CONSTRUCTION TRAFFIC MANAGEMENT PLAN

Sydney Metro West – Western Tunnelling Package

Clyde/ Rosehill Site Establishment

REVIEW COMMENTS SHEET

Figure 2-3: Existing sensitive receivers

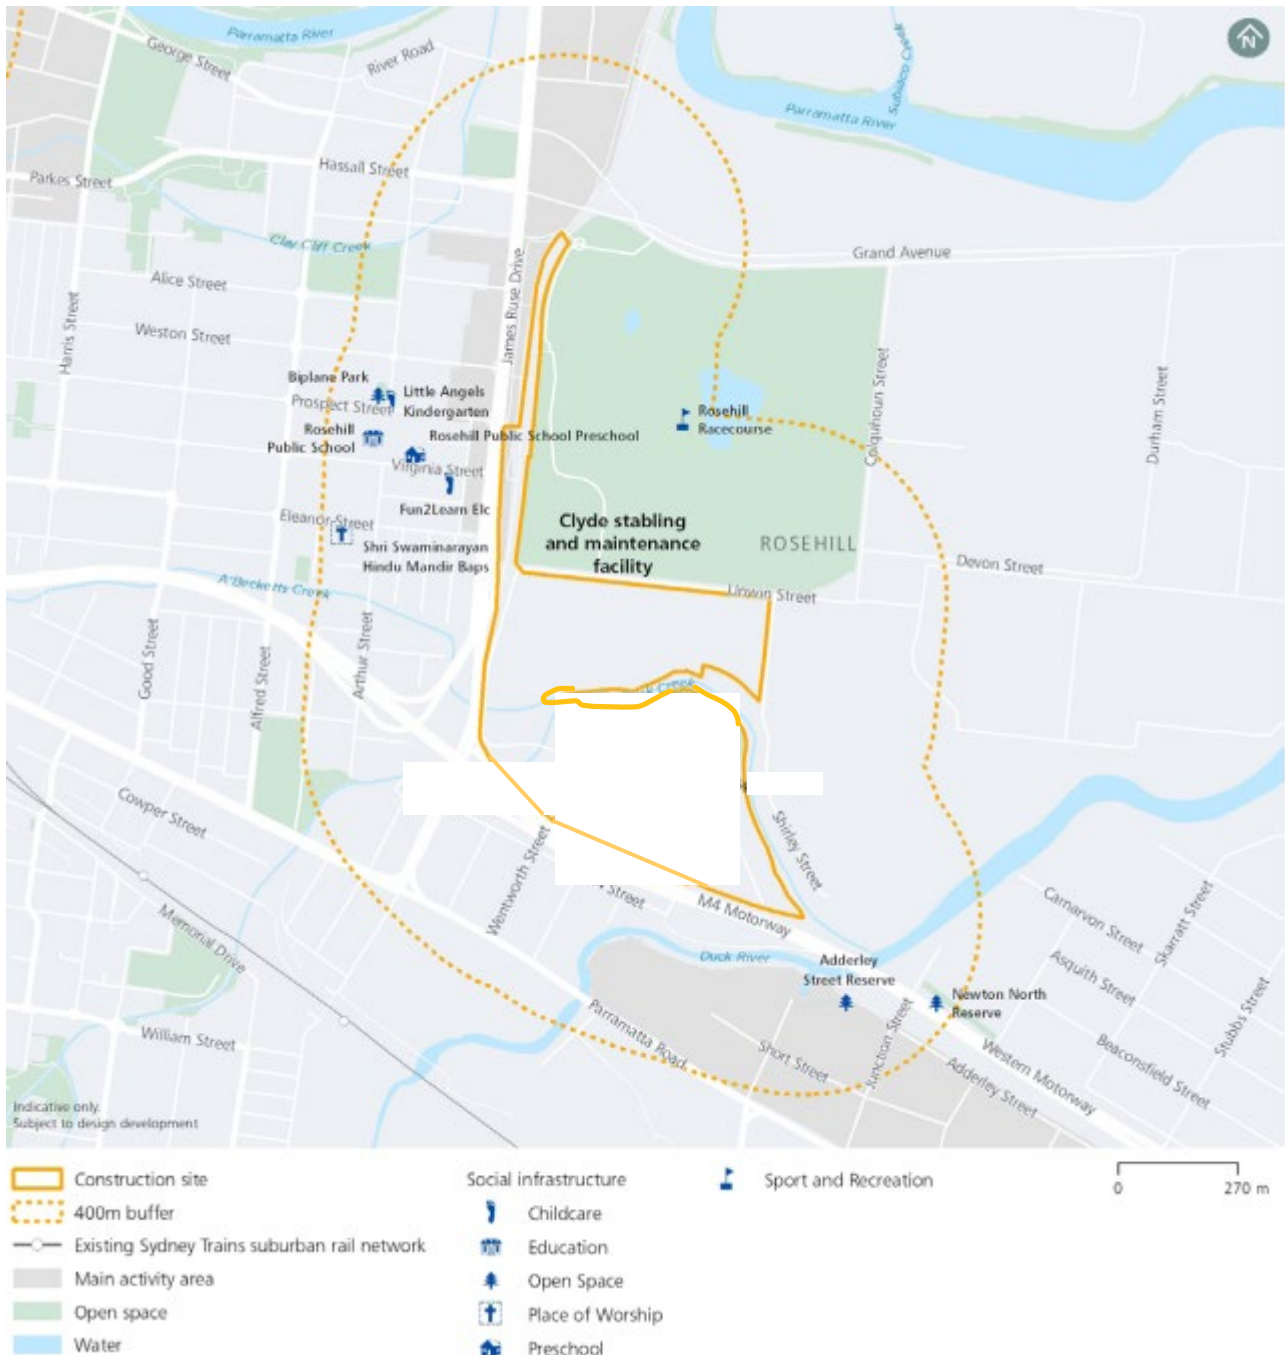
17	22/04/2022	SMD	ISUBRAMANI	SMWSTWTP-GLO-CLJ-TF-PLN-000001	figure 3 page 9	na	former sydney speedway -as Sydney Metro have acquired this land & facilitated their relocation.	Observation	N
							D KELLY	SMWSTWTP-GLO-CLJ-TF-PLN-000001	figure 3 page 9	na	Document amended	Observation	N
				18	22/04/2022	SMD	ISUBRAMANI	SMWSTWTP-GLO-CLJ-TF-PLN-000001	figure 4 page 10	na	What are the requirements for WTP to assess sensitive receivers and update since EIS?Remove references to sport and recreation within the project site. No longer relevant.	Observation	N
							D KELLY	SMWSTWTP-GLO-CLJ-TF-PLN-000001	figure 4 page 10	na	A land use survey is included as part of the detailed Noise and Vibration Impact Statement (SMWSTWTP-GLO-1NL-NL000-NV-PLN-000002). This is currently in draft and is being informed by construction from the EPA and other stakeholders. Throughout the construction period this document will be an evolving document.	Observation	N

Location:	SHIRLEY STREET		CERTIFICATE NO:	0022818927
	TCP No:	TGS-CLY-SHI-SB-2201		SIGNATURE:	
	Sheet No:	1 OF 1		PLAN CHECKED BY:	SUE LEWIS
				CERTIFICATE NO:	0022818927
				SIGNATURE:

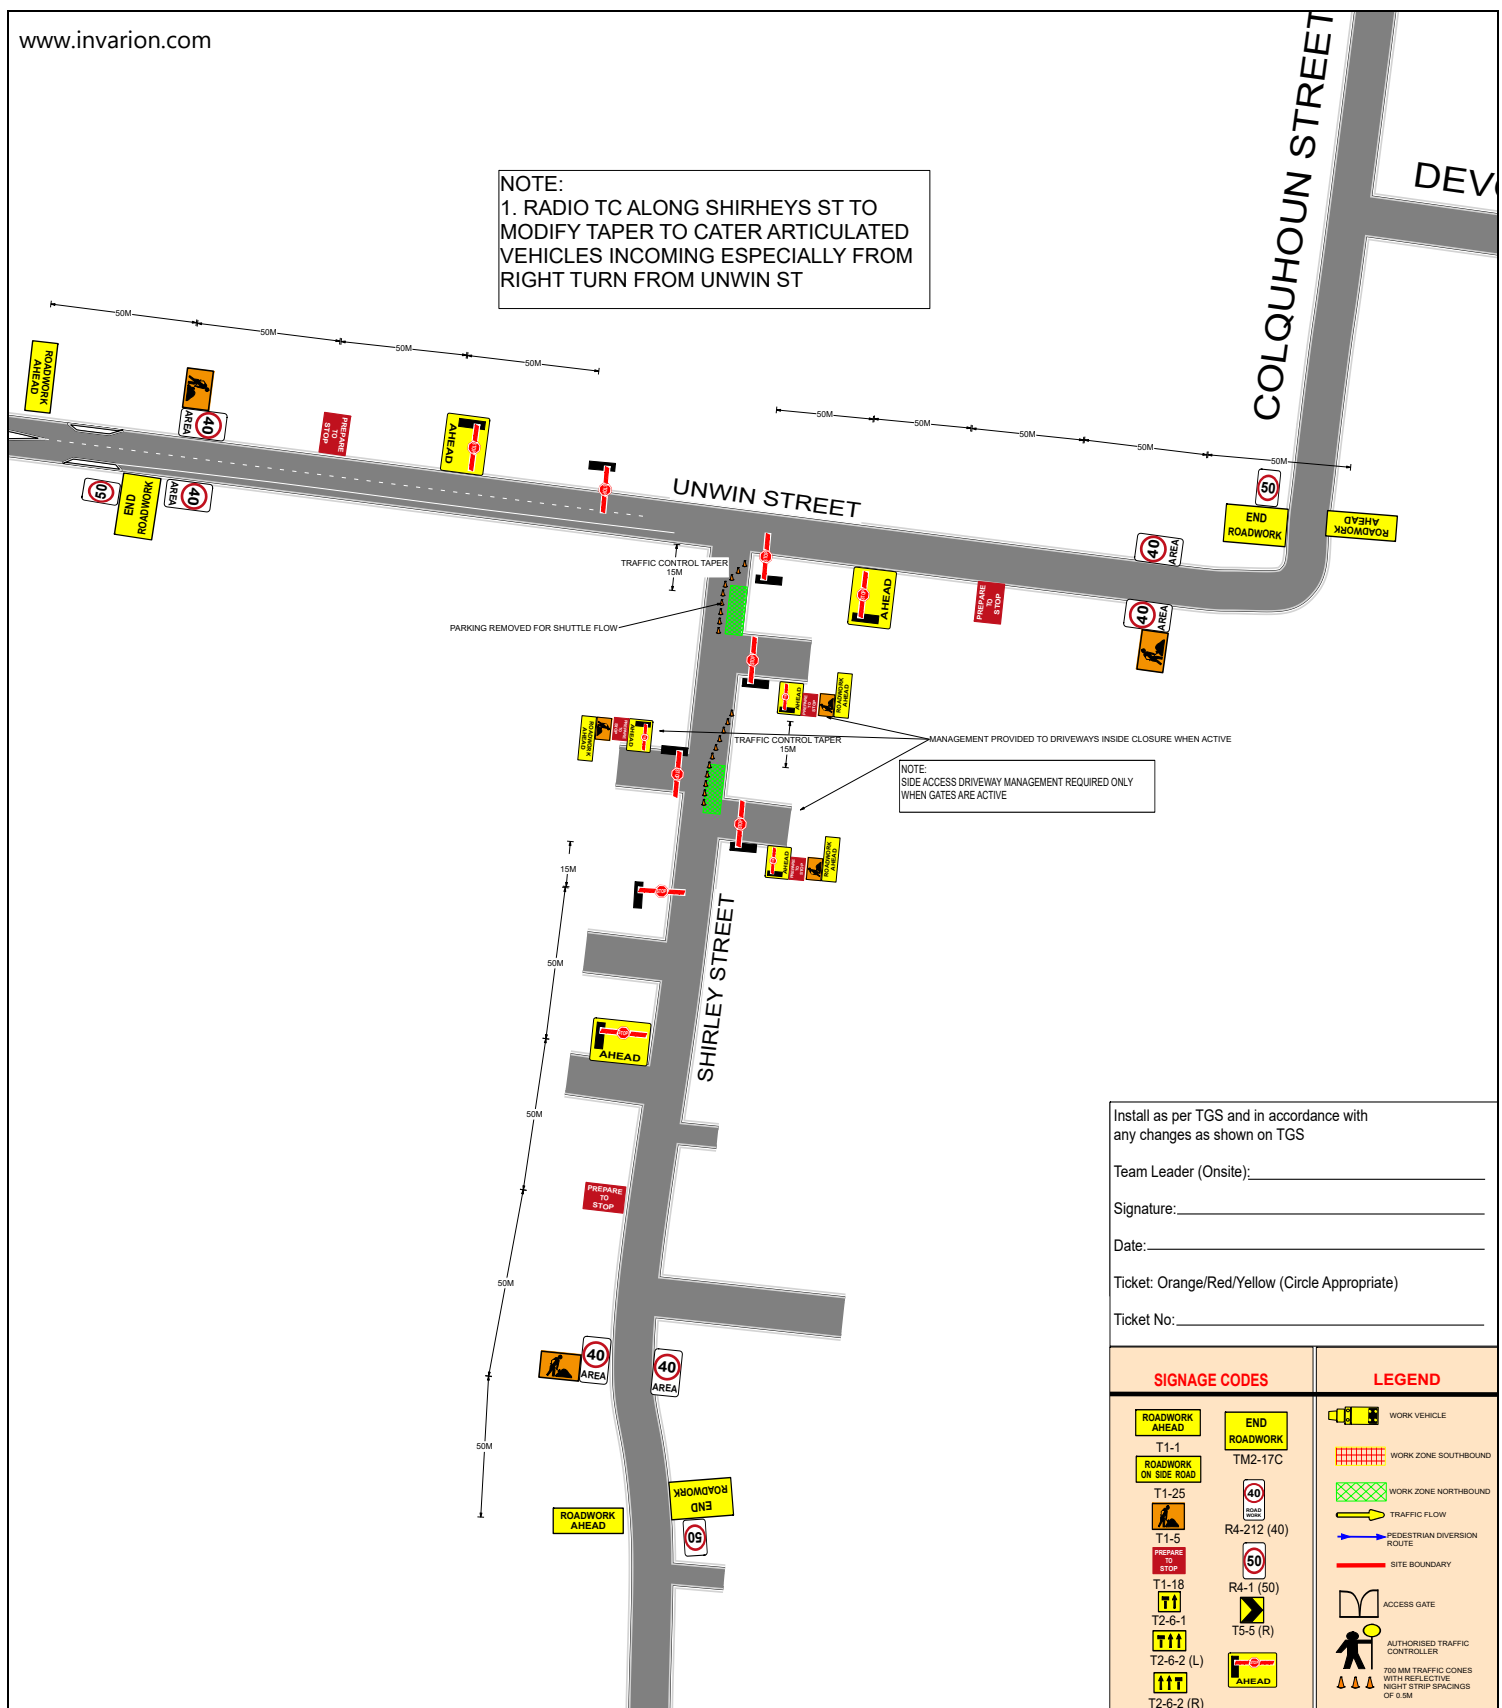
1. RADIO TC ALONG SHIRHEYS ST TO MODIFY TAPER TO CATER ARTICULATED VEHICLES INCOMING ESPECIALLY FROM RIGHT TURN FROM UNWIN ST

Area: CLYDE
Location: WENTWORTH ST
TCP No: TGS-CLY-WEN-SB-1201
Sheet No: 1 OF 1

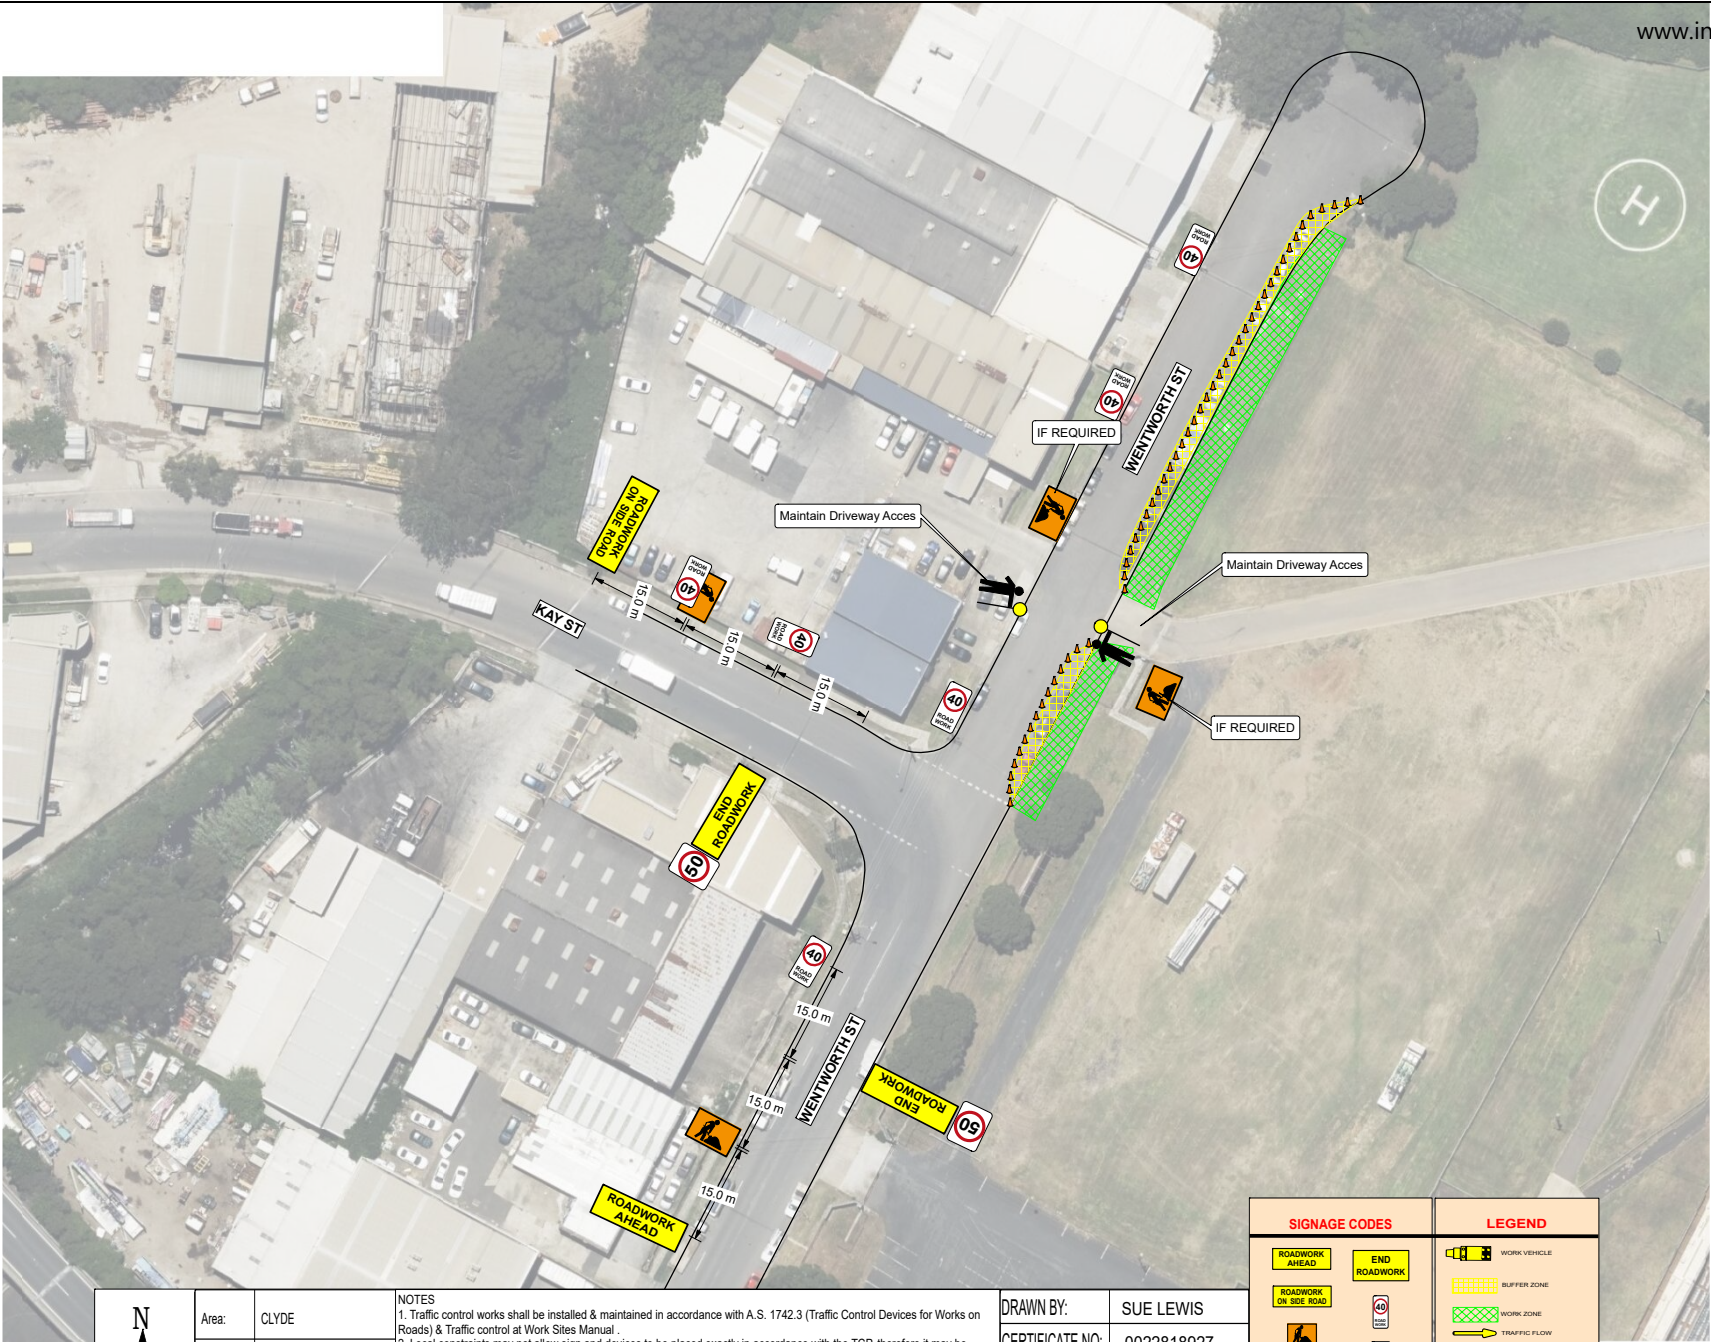
Sydney Metro West – Western Tunnelling Package Clyde Site Establishment				
	Audit Point	Treatment Option	Sue Lewis Consulting Responder:	
			Response ^x	Status ^y
TGS-CLY-WEN-SB-1201

26.	No 40km/h speed limit repeater signs are shown along Wentworth Street for the entire length where works are proposed.	Include 40km/h speed limit repeater signs. Risk: Low	TGS amended	Closed
